Parts Manual

Series 90

55cc Axial Piston Pump

Service bulletin

Servo arm change

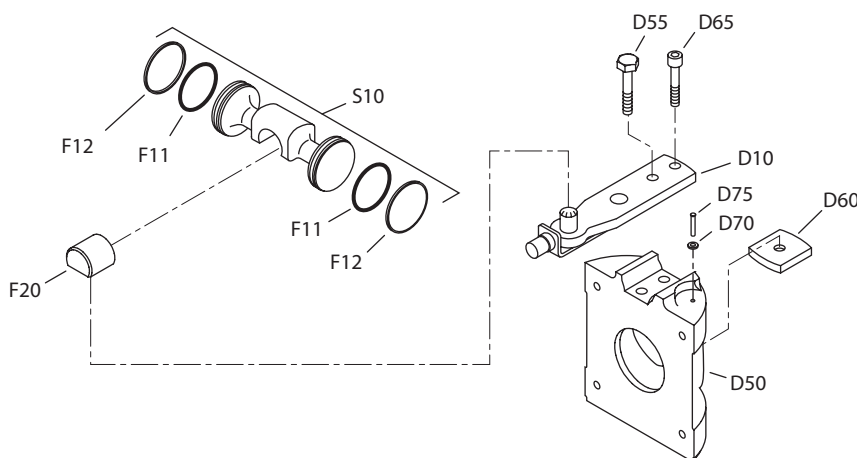
As a product improvement, Sauer-Danfoss has changed the series 90 pump servo arm and swashplate (item D10 and D50). The old style servo arm and swashplate will become obsolete. Because this change creates non-interchangeability between new and old swashplates, servo arms, and possibly servo piston (item S10) and slider block (item F20), separate servo arms and swashplates will no longer be sold as service parts.

Also, the new servo arm is actually a press fit into a groove in the new swashplate. This situation requires special tooling for assembly, therefore, pre-assembled kits will be created for 55, 75, and 100 cc pumps. The kits will work in any vintage pump.

The kit for 55 cc pumps will include all the items in the figure, except item S10

The kit for 75 cc pumps will include all item in the figure.

The kit for 100 cc pumps will include all items in the figure, except items S10 and F20.

Change goes into effect with s/n 88-14-xxxxx on 55 cc pumps and with s/n 88-16-xxxxx for 75 cc and 100 cc pumps.

Change to fixed clearance slipper hold down

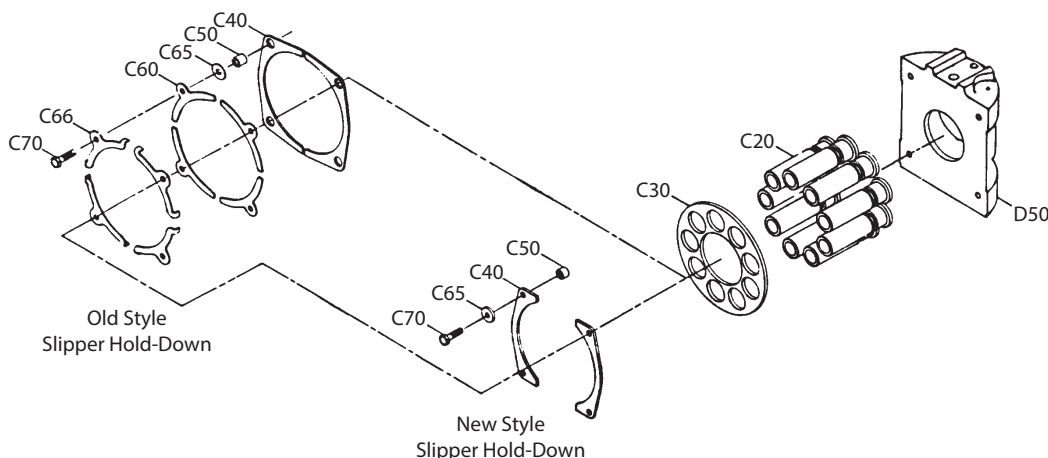
As a product improvement, Sauer-Danfoss has simplified the design of the series 90 pump slipper hold down mechanism. The hold down changes from spring loaded with a fixed maximum clearance design.

The leaf spring (item C60) and spring aligner (item C66) will be eliminated and will not be available as service parts.

The spacer (item C50), bearing (item C40), and washer (item C65) will change and the old part numbers will not be available as service parts.

Remote pressure filtration adapter change

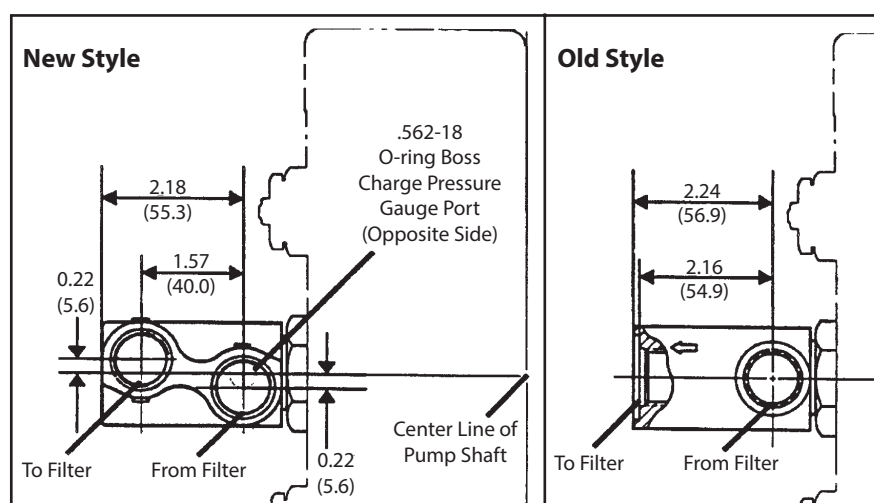
The configuration of the remote pressure filtration adapter, available as an option on Sauer-Danfoss series 90 variable pumps (55, 75, and 100 cc) is changing. This improved design adapter incorporates a charge pressure test port. In addition, the remote filter connections have been relocated to improve the customer interface and the routing for filter plumbing on most applications. Port sizes did not change. (A version of the improved design adapter is already being used on Series 90 42 cc variable pumps.)

This change does not affect the pump end cap, and either design filtration adapter can be used on any vintage pump. Only the new style adapter will be available as service parts or on new production pumps.

Charge pump design change

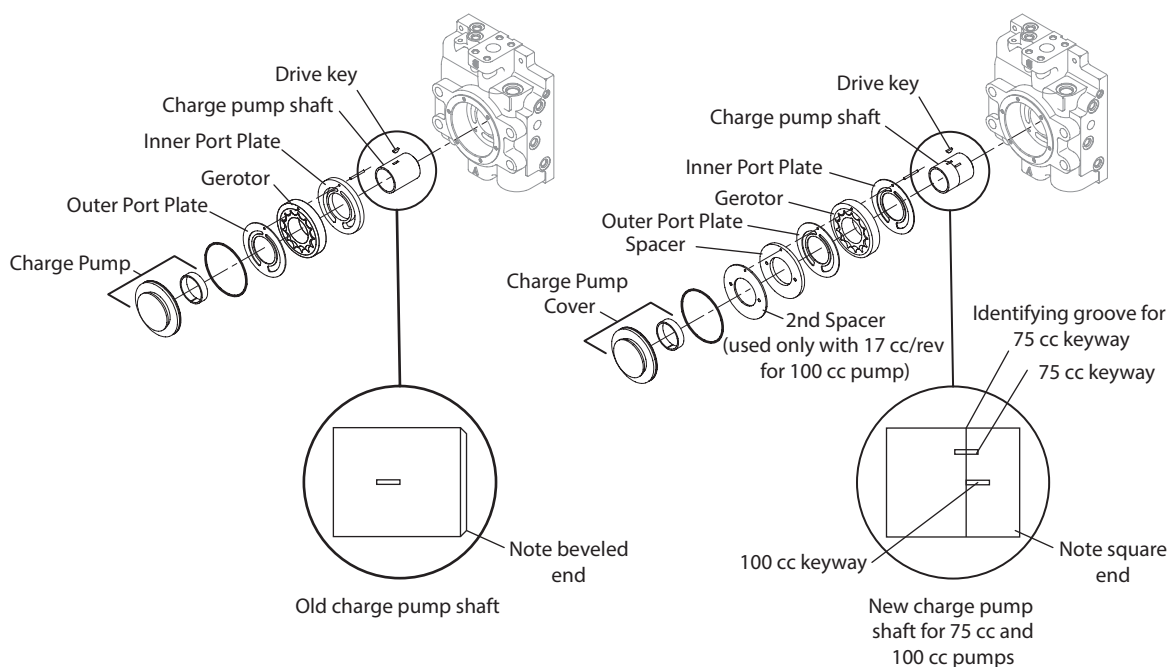
Models affected	All 94-2xxx (55 cc), 95-2xxx (75 cc), and 96-2xxx (100 cc) pumps
Serial numbers	A-89-17-xxxxx for all pumps manufactured in Ames, Iowa. N-89-07-xxxxx for al 95-2xxx (75 cc) pumps manufacture in Neumunster, West Germany. N-88-48-xxxxx for all 96-2xxx (100 cc) pumps manufacture in Neumunster, West Germany.
Part numbers affected	Proper part number versus pump serial number information can be found in the series 90 Parts Manuals. The thicker inside port plates (thicker than 0.050 in (1.27 mm) will be obsoleted and no longer available as service parts. If these parts require replacement, use the 0.050 in. 1.27 mm) port plate and appropriate spacer(s) as service parts. On 100 cc pumps only, the new charge pump shaft must be used if the new style spacer is used, On 55 and 75 cc pumps, the charge pump shaft clearance pocket in the end cap changed from a beveled to a straight corner to correspond with the change in the charge pump shaft. Old style charge pump shafts will remain available as service parts and must be used in the 55 and 75 cc beveled pocket end caps. Old style (beveled pocket) end caps will be obsoleted and no longer available as service parts. If an old style end cap needs replacement, new style end caps can be used with any vintage charge pump hardware and charge pump shaft.

Parts disposition	■ Non-interchangeable - must use correct charge pump shaft per serial number of pump

Change takes place at serial number A-89-17-xxxxx.

End cap and housing change

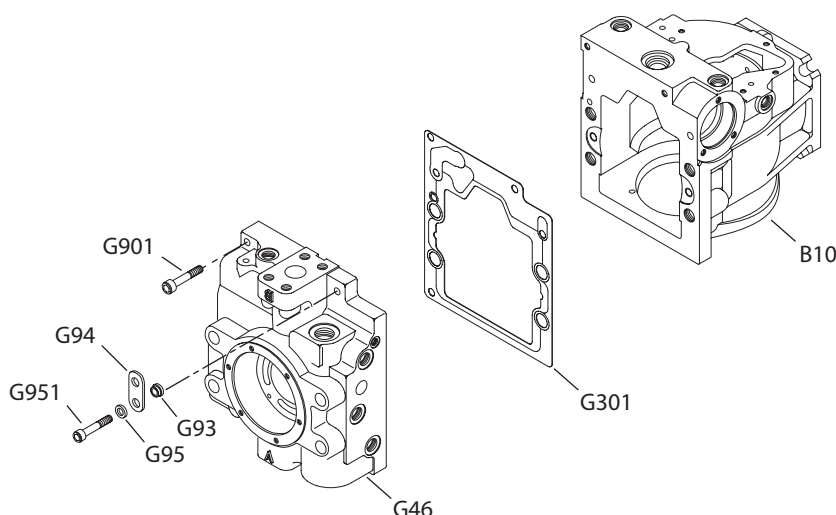
Change takes place at serial number A-89-47-xxxxx.

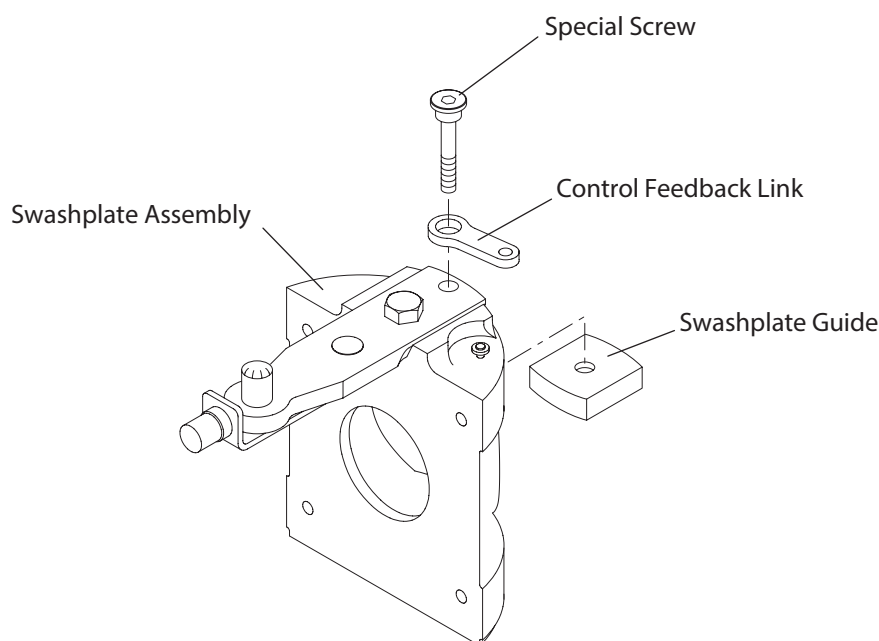
Effective in September of 1992, the feedback link in series 90 pumps will be mechanically retained to the swashplate. In the past, the link slipped over a specially ground socket head screw and could fall off the screw during assembly. The screw has changed to include a head to retain the link. The feedback link does not change.

Swashplate cage locator

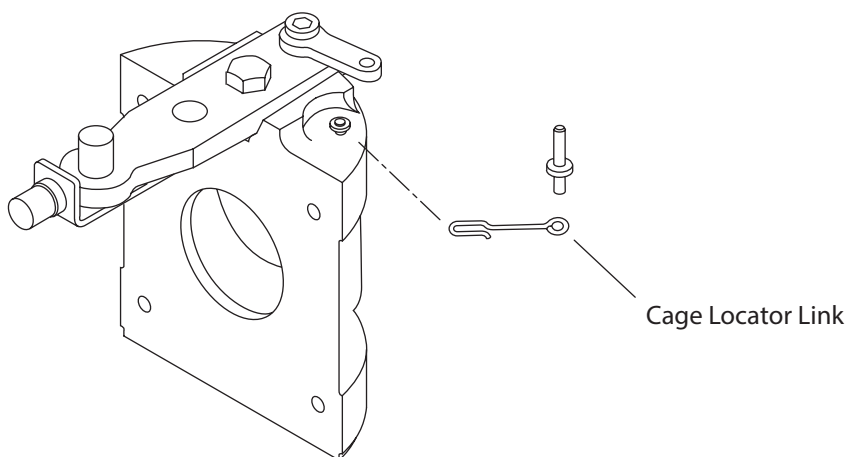
As a product improvement, Sauer-Danfoss has made a design change to the cage locator link used on the 55 thru 100 cc variable pumps.

The new link is made from square wire. In the past, the link was made from round wire. This is an interchangeable change.

Side cover washer elimination

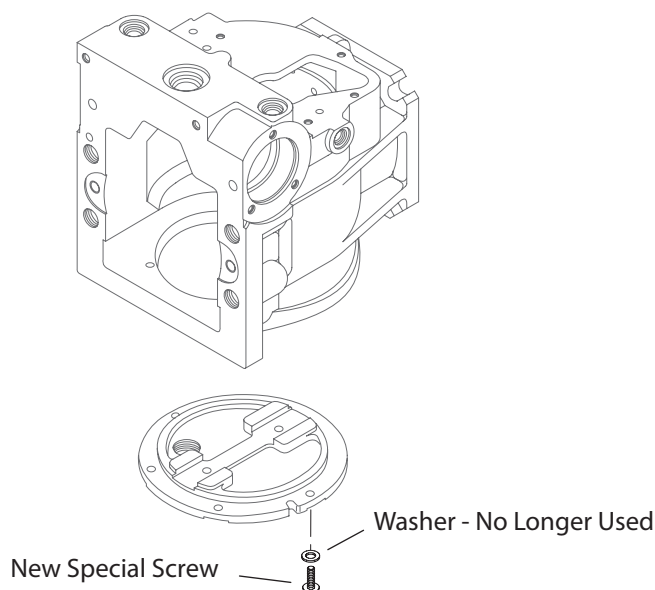
Change took place during the 2nd and 3rd quarter of 1994

Integral filtration manifold

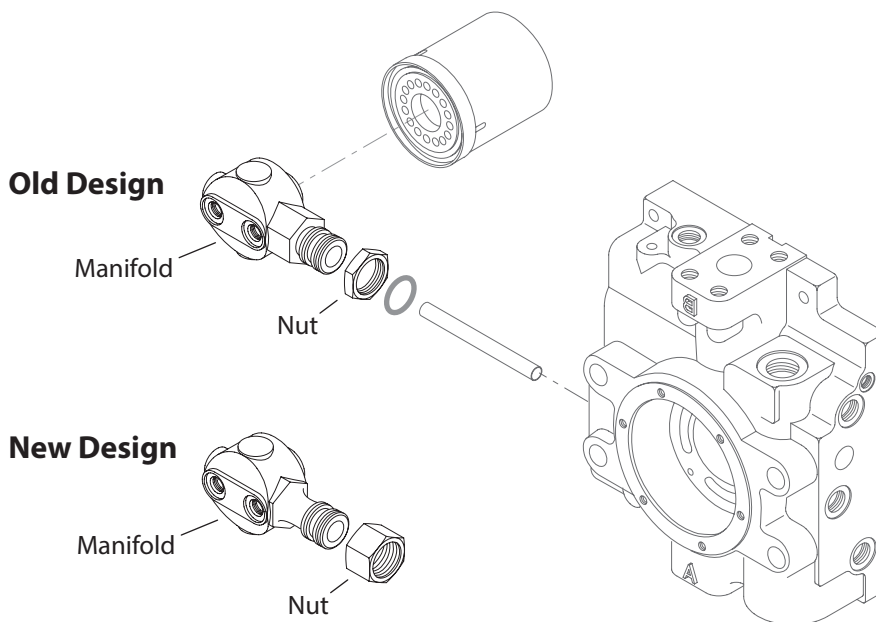
Change occurred at serial number 95-18-xxxxx

Subject Swashplate bearing cage locator pin

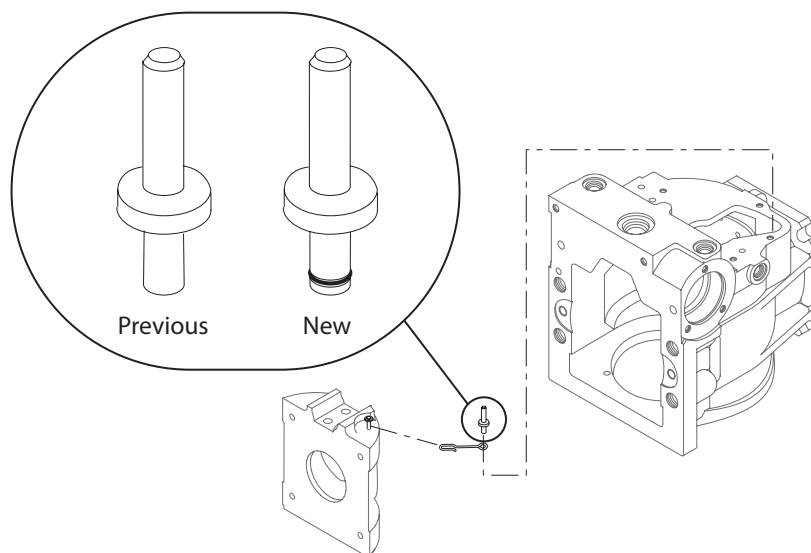
Description Sauer-Danfoss has modified the design of the swashplate bearing cage locator pin used in the series 90 55, 75, and 100 cc variable displacement pumps.

To aid in identifying this change, Sauer-Danfoss has released a new part number for the updated pin design. The new pin is completely interchangeable with the previous pin part number. The previous pin has been obsoleted.

Serial numbers This change became effective at serial number 98-24-xxxxx

Charge pump shaft part number change

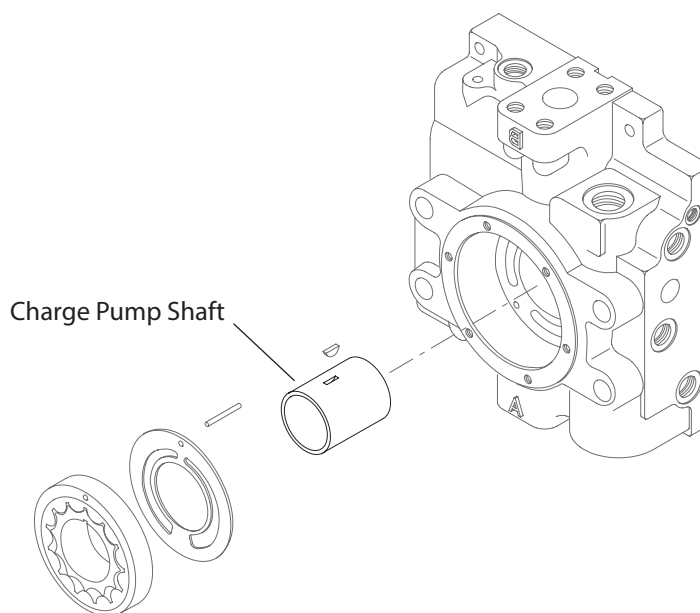
As a product improvement, Sauer-Danfoss has modified the design of the charge pump shaft used in series 90 55, 75 and 100 cc pumps. This change affects all charge pump sizes (11, 14, 17, 20, 26, and 31 cc) available in the series 90 displacement range.

The series 90 55 cc variable displacement pump uses the same charge pump shaft, regardless of charge pump size (11, 14, or 17 cc). The series 90 75 and 100 cc variable displacement pumps, utilize a common charge pump shaft for the standard size charge pumps (75 cc standard equals 14, 17, and 20 cc and 100 cc standard equals 17, 20, and 26 cc).

The design modification includes a surface finish change to the charge pump shaft which improves the wear characteristics between the charge pump shaft and the journal bearings in the charge pump cover and end cap.

To assist in identifying this change, Sauer-Danfoss has released new charge pump shaft part numbers. The new shafts are completely interchangeable with the previous shafts. The new shaft has replaced the previous shaft in new pump assemblies and charge pump service kits. The previous shafts have been obsoleted and are no longer available as a service part. The chart on the next page will assist you in determining the part number changes.

NOTE: Pump models 9621723 and 9622117 were released with a special charge pump option (code W - 26 cc charge pump with special shaft). With this product modification, the charge pump option code for these two models has been changed from W to the standard option (code F - 266 cc charge pump). The special shaft part number 8801176 has been obsoleted and replaced with shaft part number 8801178.

Auxiliary flange charge pump cover

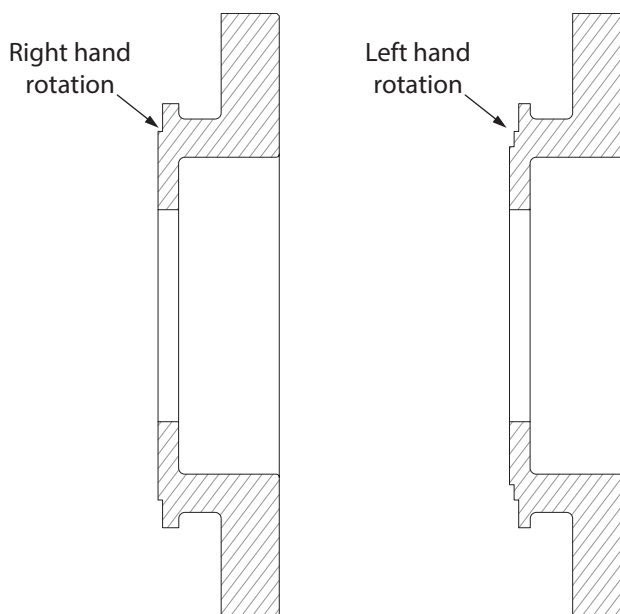
The part numbers of the charge pump covers will not change.

This change became effective at serial number A-05-17-xxxxx

Subject SAE C auxiliary mounting flange

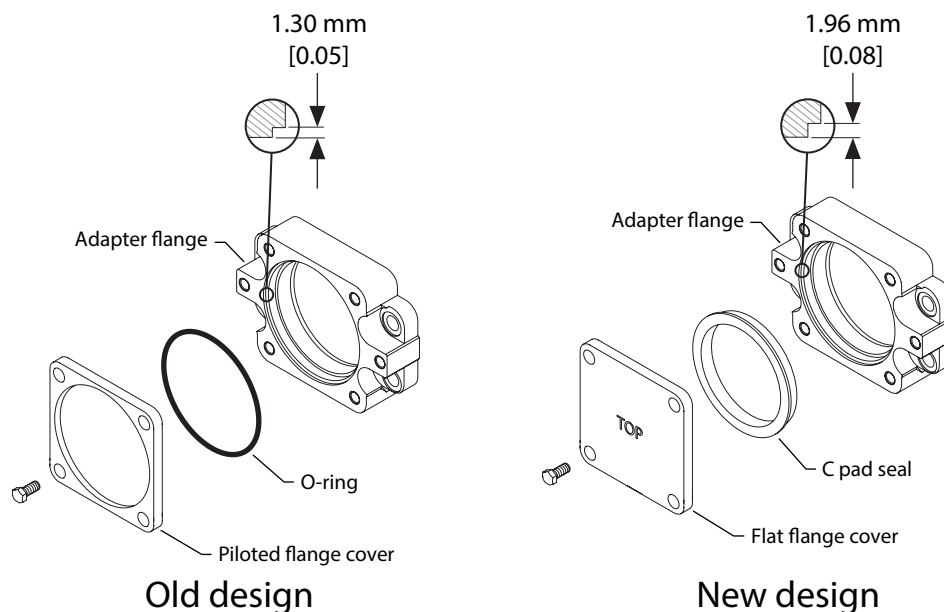
Part numbers affected Sauer-Danfoss is pleased to announce a design improvement on the SAE C auxiliary mounting flange adapter on its series 90 pumps. The frame sizes affected by this change are 55, 75, and 100cc. All manufacturing locations producing these pumps will be changed to this configuration.

The pumps will now be supplied with the donut style seal and new flat cover, instead of the small O-ring and cover plate (shown in the drawing below).

Serial numbers This change became affective at serial number; A 08-19-xxxxx and N 09-30-xxxxx.

Subject SAE B auxiliary mounting flange

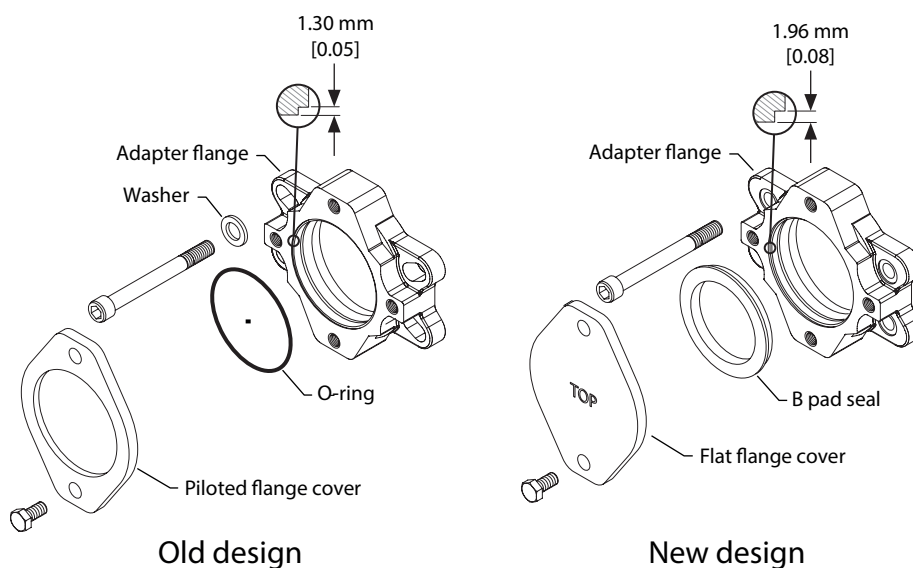
Part numbers affected Sauer-Danfoss is pleased to announce a design improvement on the SAE B auxiliary mounting flange adapter on its series 90 pumps. The frame sizes affected by this change are 55, 75, and 100cc. All manufacturing locations producing these pumps will be changed to this configuration.

The improvement comes in the form of a more robust sealing geometry with a larger cross-section O-ring. The O-ring groove in the flange will now be sized to mate with a 2.62mm [0.103] cross section O-ring rather than the old 1.78mm [0.070] cross-section O-ring. The Sauer-Danfoss part number for the new O-ring is 9004104-1540 (2.62mm [0.103] x 94.92mm [3.737]). The larger cross-section sealing geometry allows for the use of a donut style B pad seal and a new flat cover for improved assembly. This new configuration is qualified as a running cover. When installing an auxiliary pump, the donut style B pad seal must be discarded and part number 9004104-1540 O-ring used.

Also, the flanges will no longer have a slotted interface with a washer for the end cap screws. The flanges will now have round through holes for the end cap screws and will use no washers. The end cap screws do not change. This eliminates the area where water or high pressure wash chemicals can be trapped around the end cap screws. There now are specific part numbers for the flanges used on each of the three displacement size pumps; 55, 75 and 100 cc.

The pumps will now be supplied with the donut style seal and new flat cover, instead of the small O-ring and cover plate (shown in the drawing below).

Serial numbers This change became affective at serial number; A 08-19-xxxxx.
